**RE: FIRST SECURITY BANK (D17-D59). GRADING AND DRAINAGE PLAN FOR
BUILDING PERMIT APPROVAL. ENGINEER'S STAMP DATED SEPTEMBER 5,
1997.**

FIRST SECURITY BANK
JEFFERSON BRANCH ADDITION
GRADING AND DRAINAGE PLAN
PROJECT# 9739

GRADING AND DRAINAGE PLAN

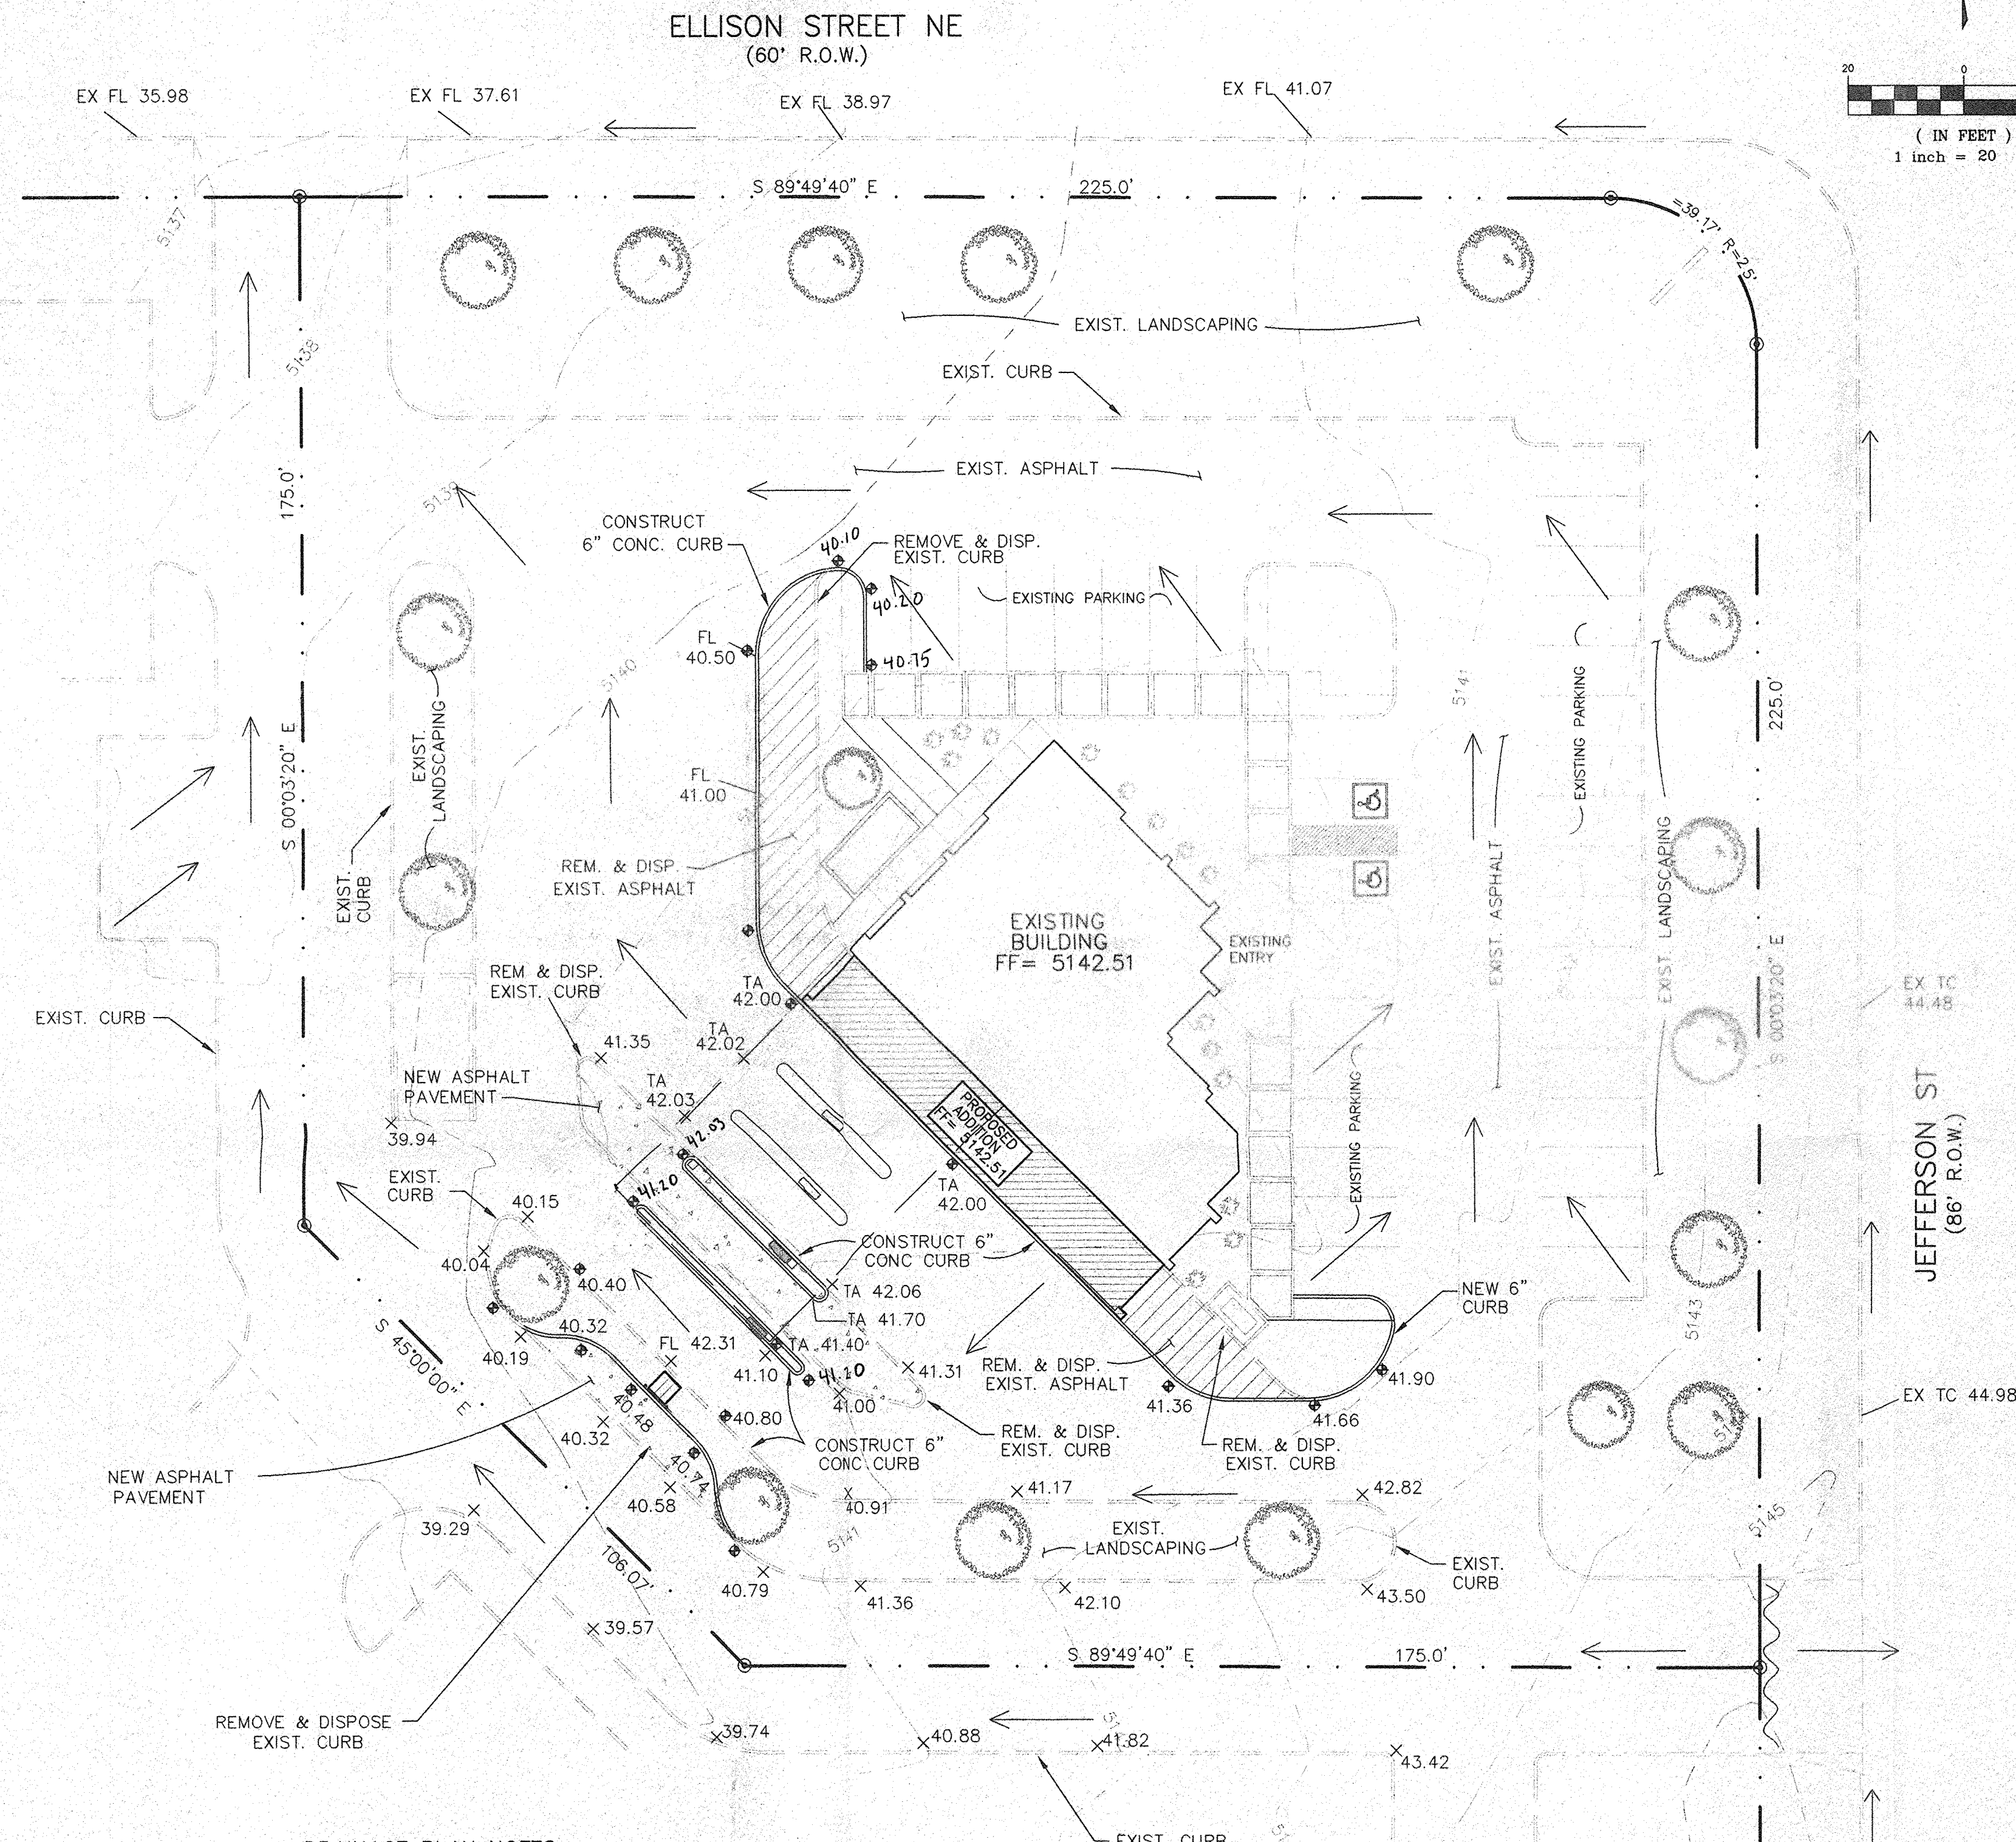
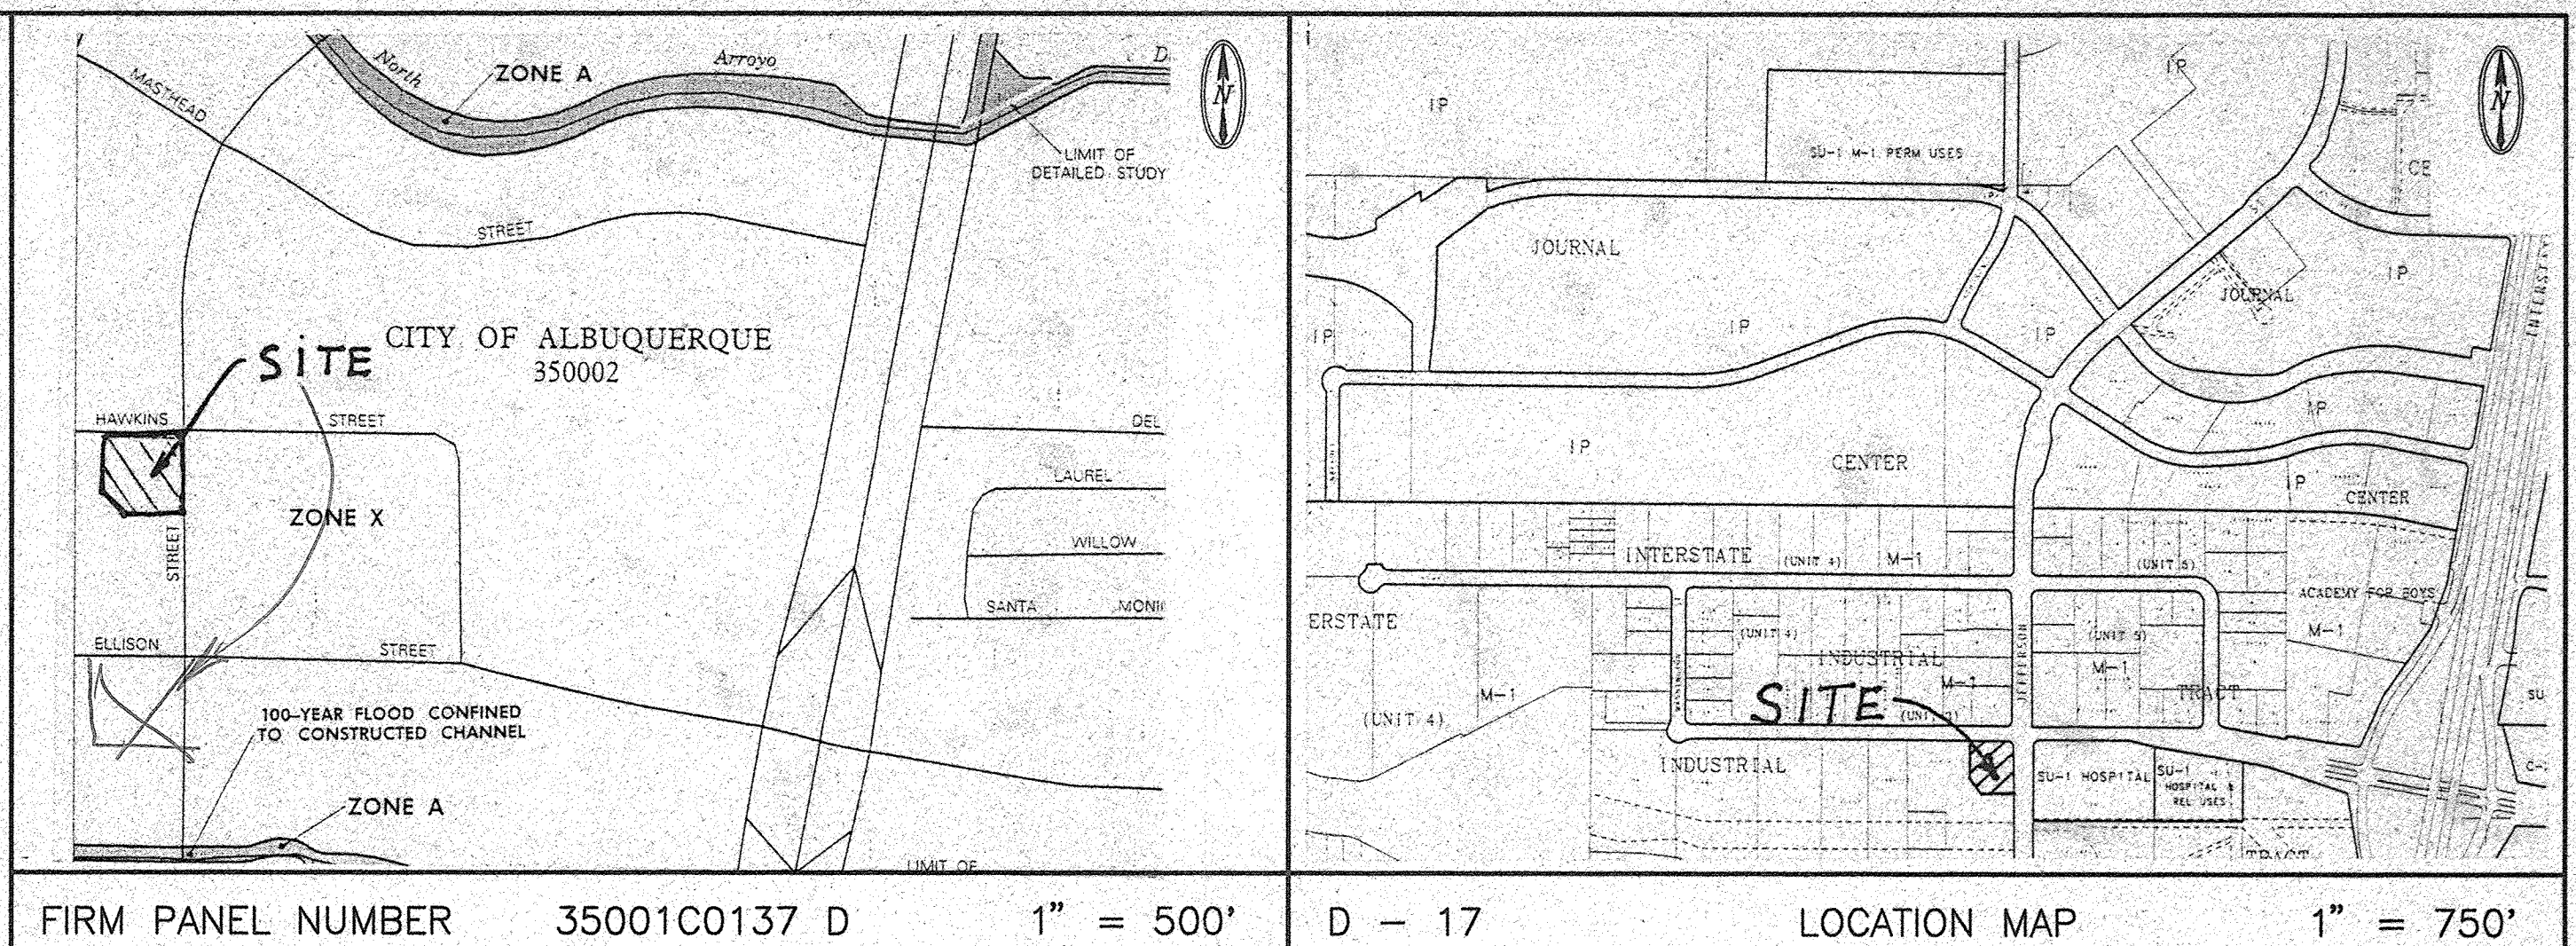
Based on the information provided on your September 8, 1997 submittal, the above referenced project is approved for Building Permit.

Prior to Certificate of Occupancy approval, an Engineer's Certification will be required.
